SERVICE LETTER

No. 556A

Piper Aircraft Corporation

Subject: Turbocharger Waste Gate Return Spring

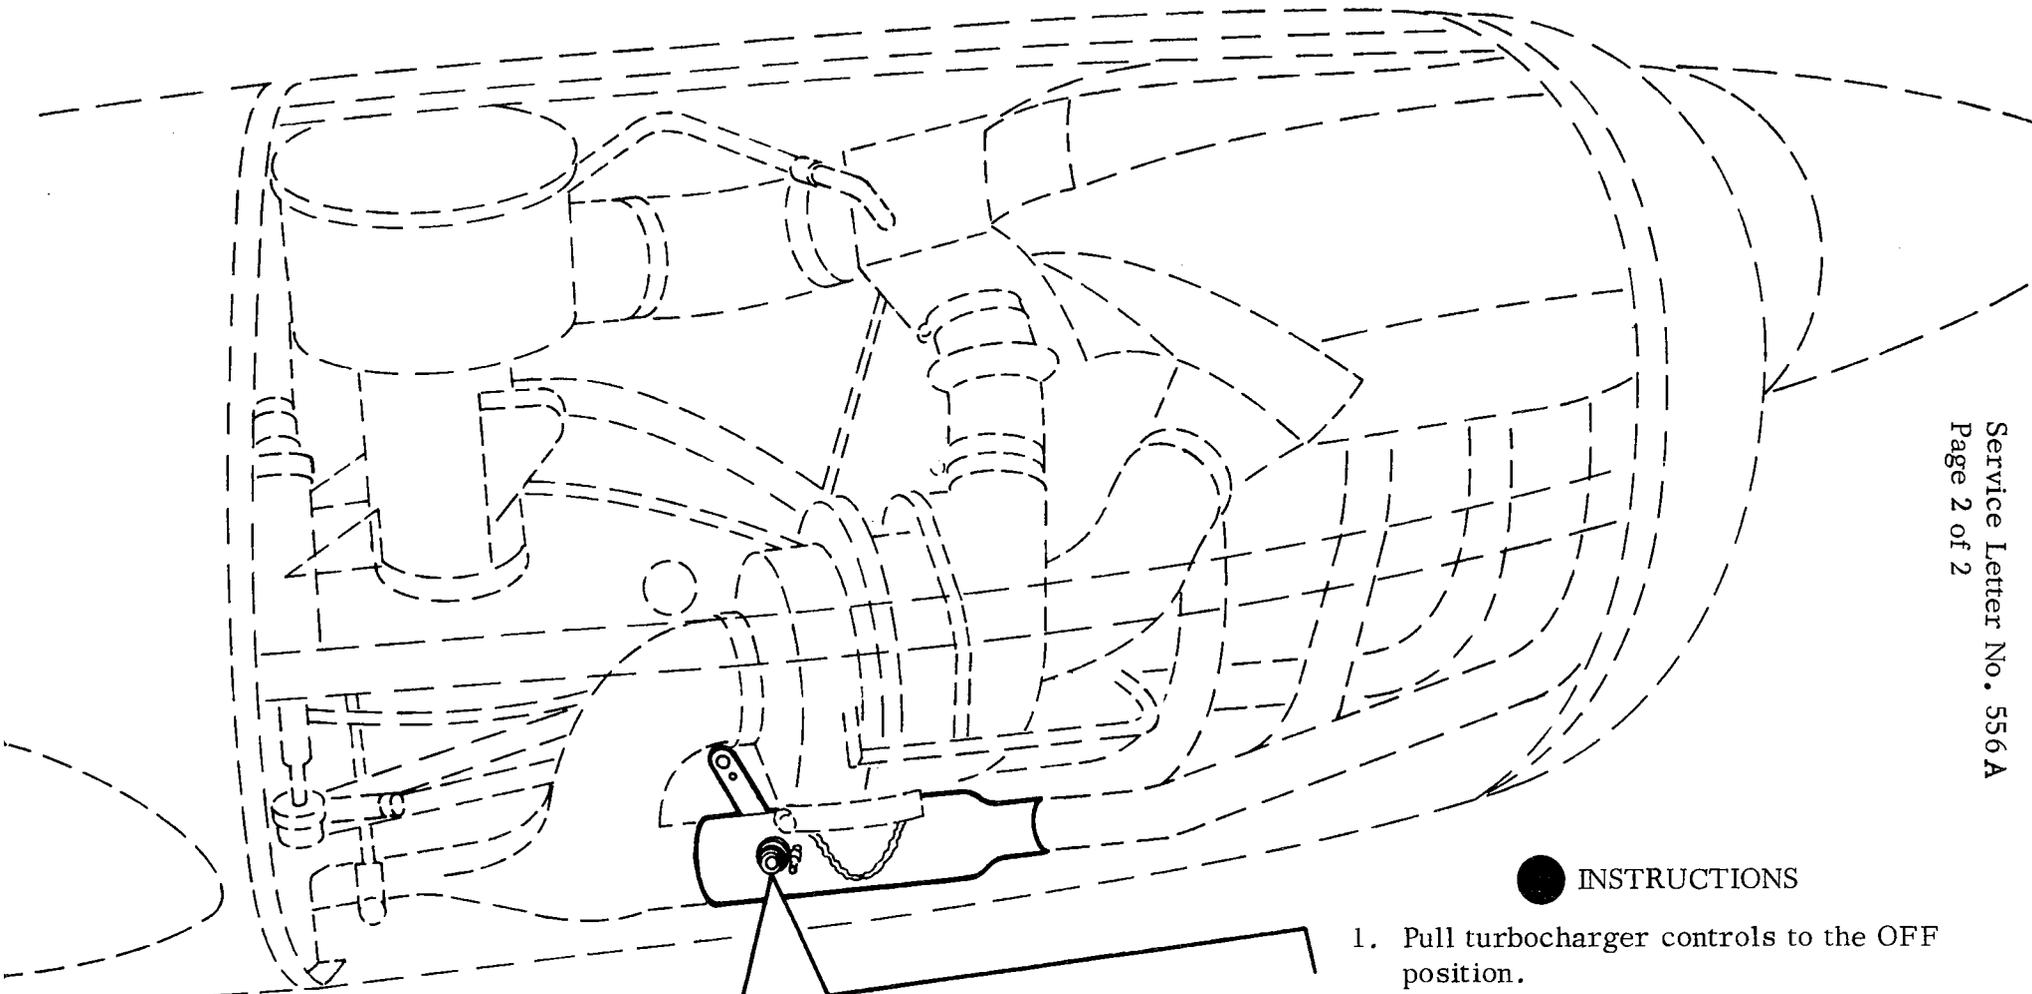
Instructions: Replace the existing waste gate return spring with new waste gate return spring, Rajay part number RJ 4120-11, refer to sketch on reverse side of this letter for installation instructions.

1. Pull turbocharger controls to the OFF position.
2. With side and bottom cowl panels removed, remove the existing turbocharger waste gate spring.
3. Install new turbocharger waste gate spring, RaJay Part Number RJ4120-11, being careful to install center tang in hole 180° to hole from which old spring was removed.
4. Place turbocharger waste gate spring on spring retainer as shown.
5. Actuate turbocharger controls to determine spring winds and unwinds freely.
6. Reinstall cowl.
